Model: All Commander™ Drawworks Serial #: All	Mar. 5, 2015
Product Bulletin # DW-002

Johnson Brakes 68HHH Upgrade

Figure 1: Trunnion and Toggle Links Nuts and Bolts

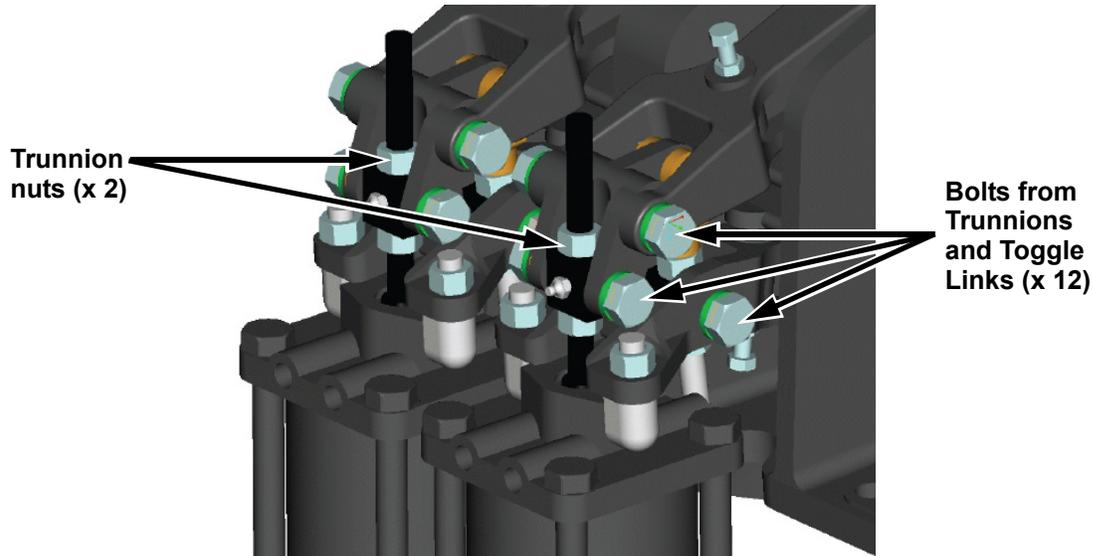
2. Start the upgrade with the brake in the **SET** position.
3. Loosen, but do not remove trunnion nuts (x 2). See Figure 1 on page 2.
4. Set the brakes to the **RELEASE** position and cage the actuators. Support the weight of the actuators.

5. Remove all bolts from the trunnions and toggle links (x 12). See Figure 1.
6. Pull out the following as one sub-assembly: both sets of toggle links, clevis, clevis pin, rod and trunnion.
7. Tighten the tensioning nut against the base of the piston rod See Figure 2 on page 3.

Figure 3: Toggle Link, Trunnion Block, and Nut

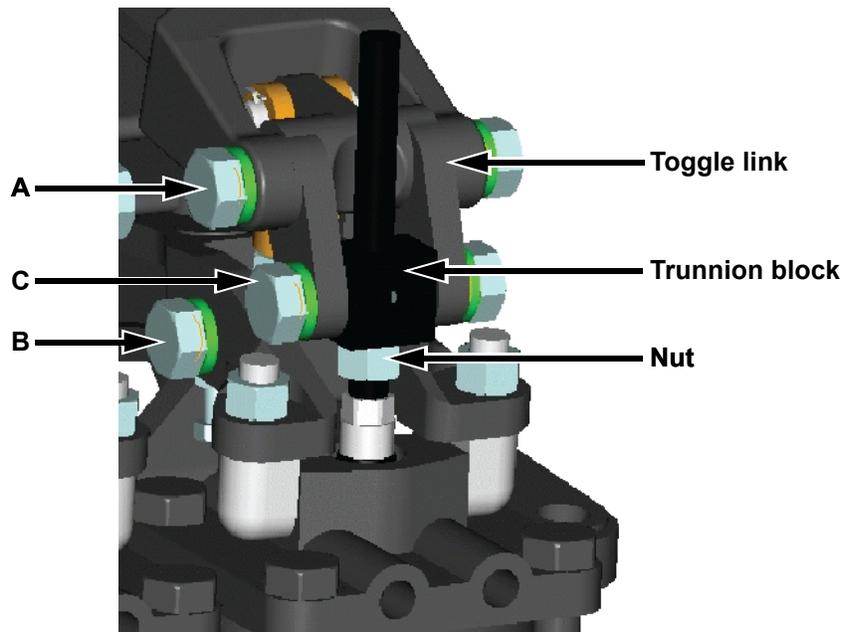
- a. Tighten nut.
- b. Slide trunnion block back on.
- c. Fix toggle link in place. Follow order A, B, C as indicated in Figure 3.

10. Torque all trunnion bolts to 410 ft-lb.
11. Tighten all bolts. Torque tension nuts to 200 ft-lb. See Figure 3.

Figure 4: Torque tensioning nuts last.

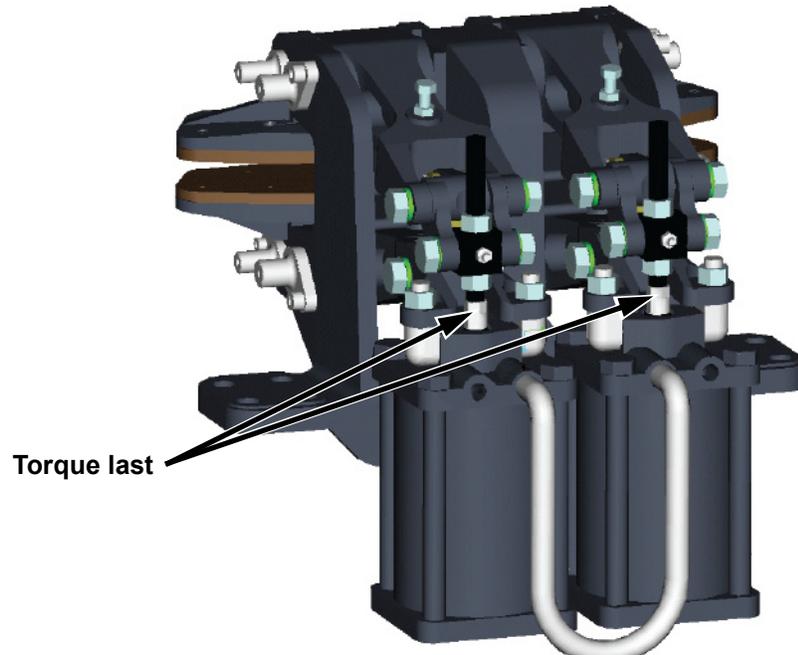
Note: Tensioning nuts must be torqued last. See Figure 4 on page 5.

Figure 5: Exploded View

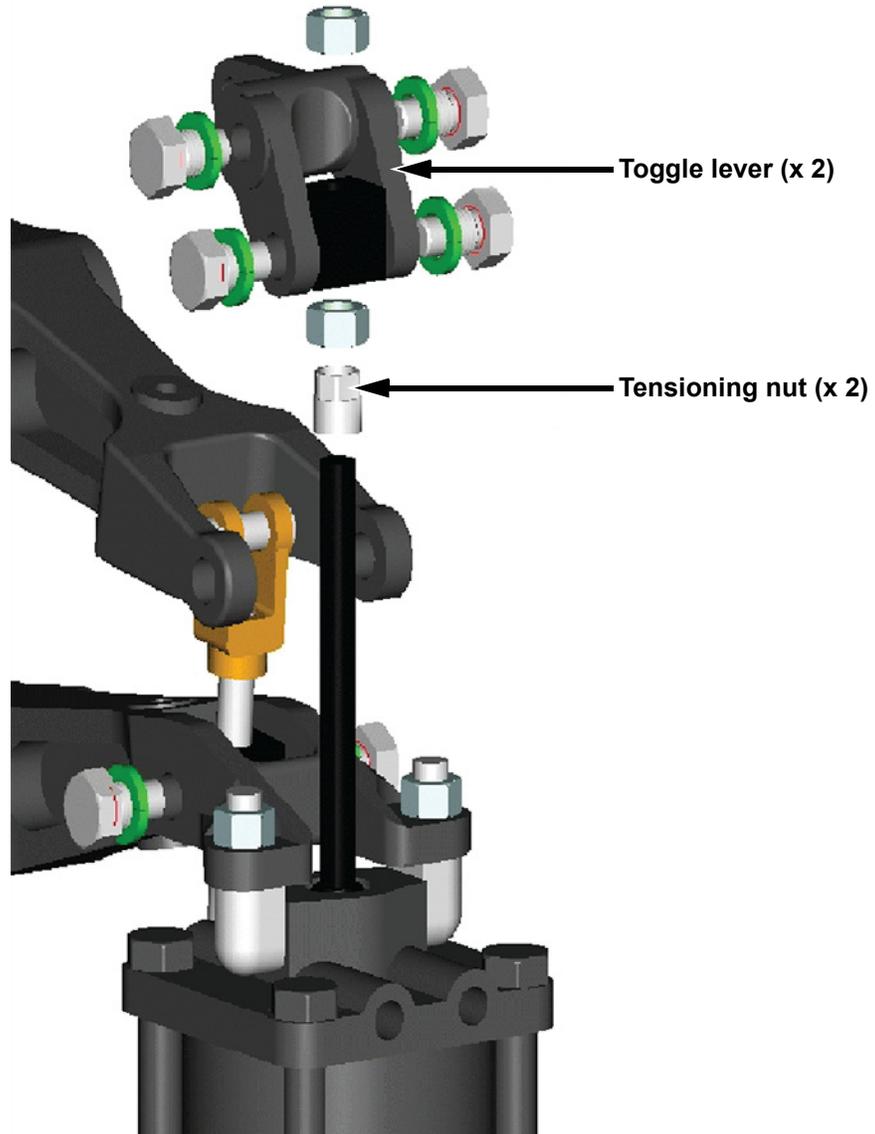
8. Replace toggle levers with the upgrade parts. See Figure 5 on page 6.
